Issued:	Date:
A CITY SUBMITAL #1	05/12/23
B	
C	
D	
E	
Revisions:	Date:
1	
2	
3	
4	
5	
6	
7	
8	
9

ALDI Inc. Store #: 143
RAMSEY, MN
7992 SUNWOOD DR NW
RAMSEY, MN 55303
ANOKA

Project Name & Location:
LANDSCAPE DETAILS

Drawing Name:	ISG Project No.
Type: V7.0 ER	23-21339
Drawn By: AE	
Designed By: AE	C-520
Reviewed By: MRW	Drawing No.

DECIDUOUS TREE PLANTING
NTS

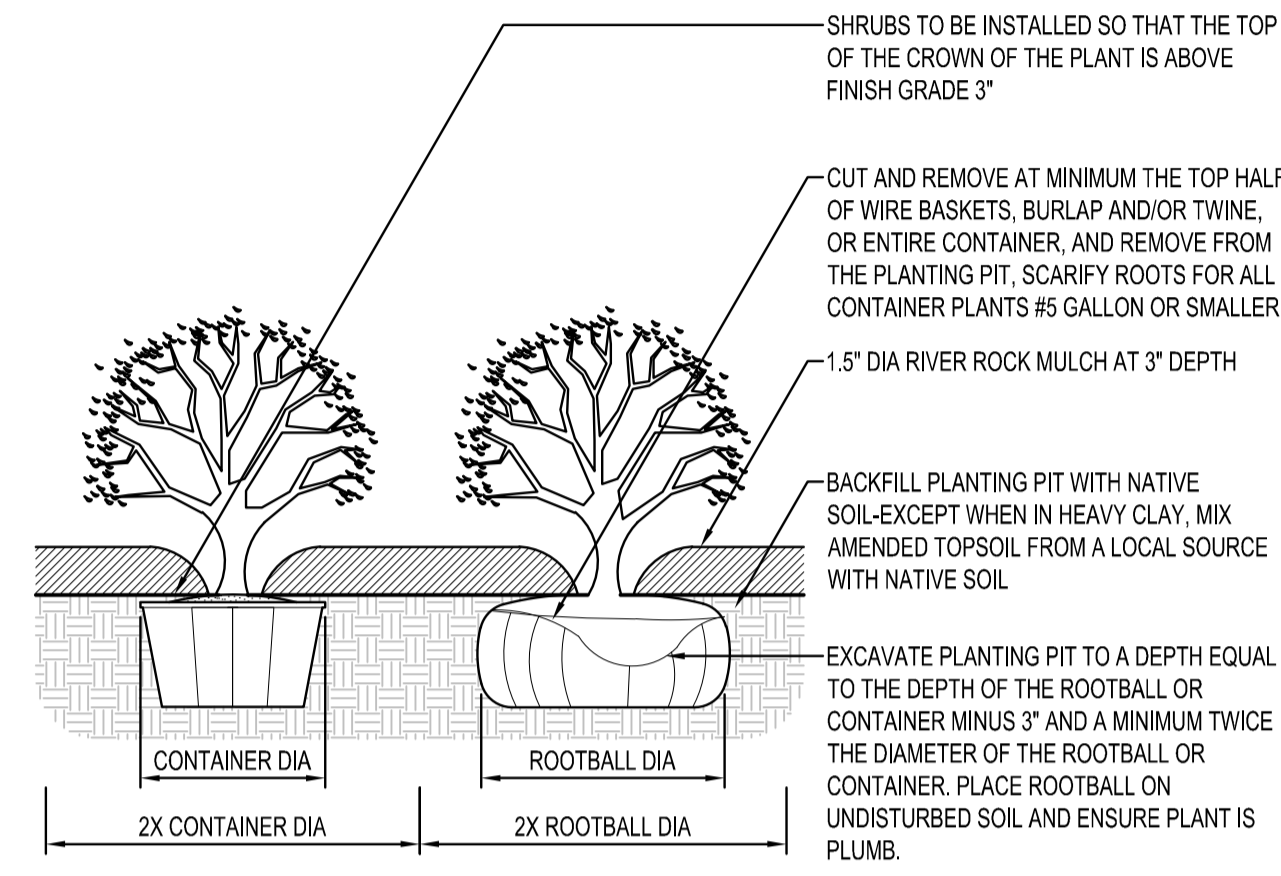
1 - Pruning Cuts

Do not make flush cuts. The branch bark collar and ridge shall remain in tact.

2 - Root Flare

Root flare shall be flush with finished grade or no more than 2" above finished grade.

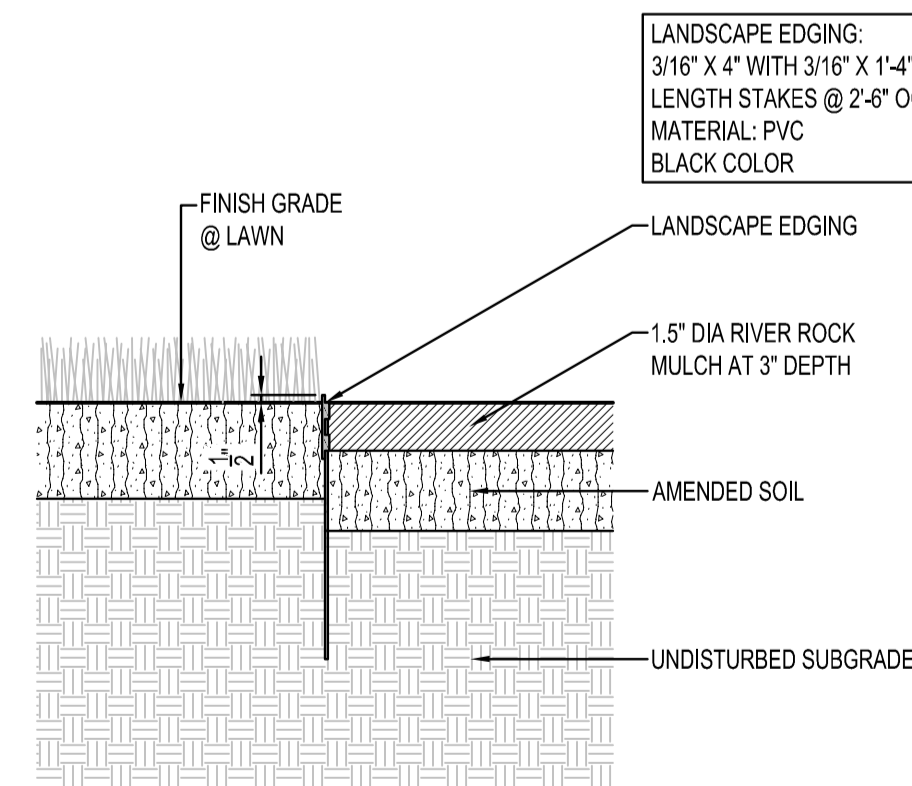
3 - City Approval Required

Any deviations from the approved landscape plan require prior approval of the City.

4 - Warranty

The Development Agreement will require a 2-year warranty period.

5 - Parking Lot Islands

Do not use riverrock in the parking lot islands. This must be an organic material such as hardwood mulch.

6 - Topsoil

Add note to either this sheet or the Landscape Plan stating that 4 inches of topsoil, with no more than 35% sand content is required over all disturbed areas not otherwise improved with impervious surfacing. A topsoil inspection is required prior to installation of landscaping.

7 - Irrigation

Will an irrigation system be installed? If so, please provide details. Any irrigation system installed shall include a rain sensor and some form of water efficient technology, such as a weather compensating smart controller.
